Case Number: Z-19-12

Certified Recommendation

Raleigh Planning Commission

Case Information: Z-19-12 / MP-1-12 - Homewood Banks Dr. & Blue Ridge Rd.

Figure 1: Intersection Delay at Glenwood Avenue and Blue Ridge Road

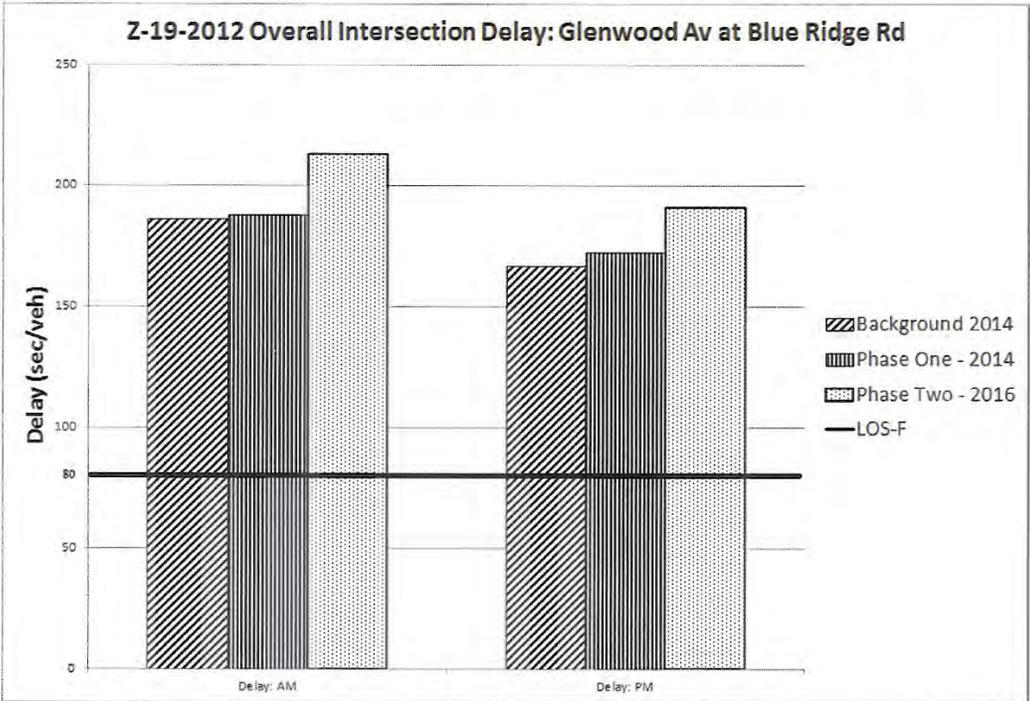
It is not practical to mitigate the delay or improve level-of-service at Glenwood Avenue and Blue Ridge Road for several reasons. Traffic signals along both Glenwood Avenue and Blue Ridge Road are coordinated; any attempt to retime the signal at Blue Ridge Road would require adjusting other signals such as Creedmoor Road, Crabtree Valley Mall, etc. Constructing additional lanes on Blue Ridge Road to reduce queuing is not possible; there is insufficient right-of-way to add more lanes.

Figure 1: Intersection Delay at Glenwood Avenue and Blue Ridge Road

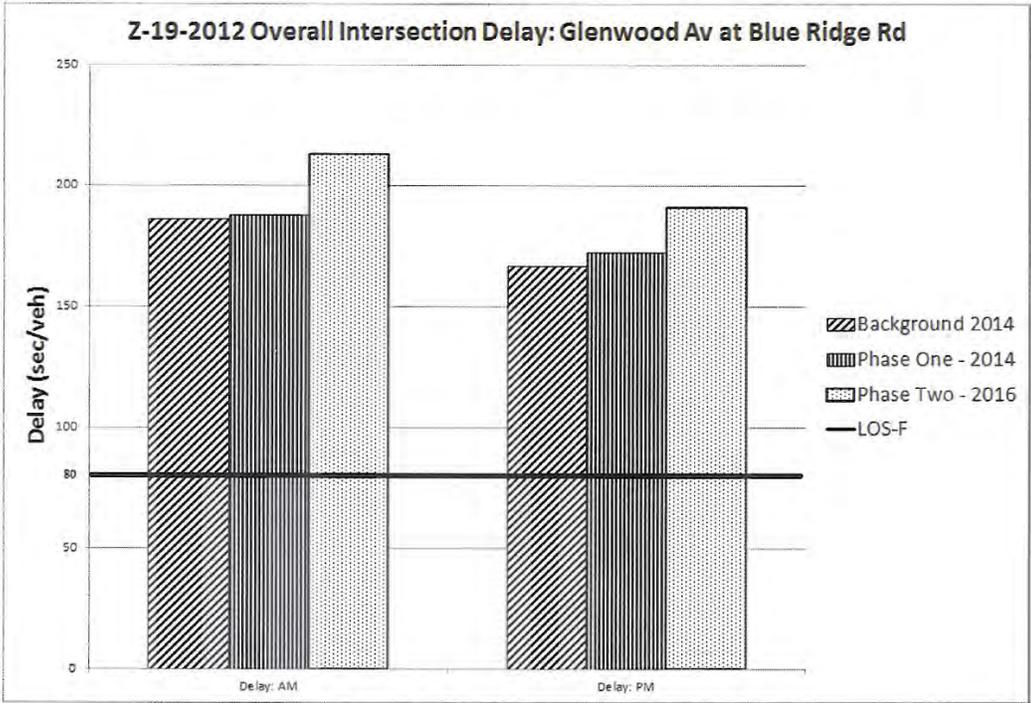
It is not practical to mitigate the delay or improve level-of-service at Glenwood Avenue and Blue Ridge Road for several reasons. Traffic signals along both Glenwood Avenue and Blue Ridge Road are coordinated; any attempt to retime the signal at Blue Ridge Road would require adjusting other signals such as Creedmoor Road, Crabtree Valley Mall, etc. Constructing additional lanes on Blue Ridge Road to reduce queuing is not possible; there is insufficient right-of-way to add more lanes.
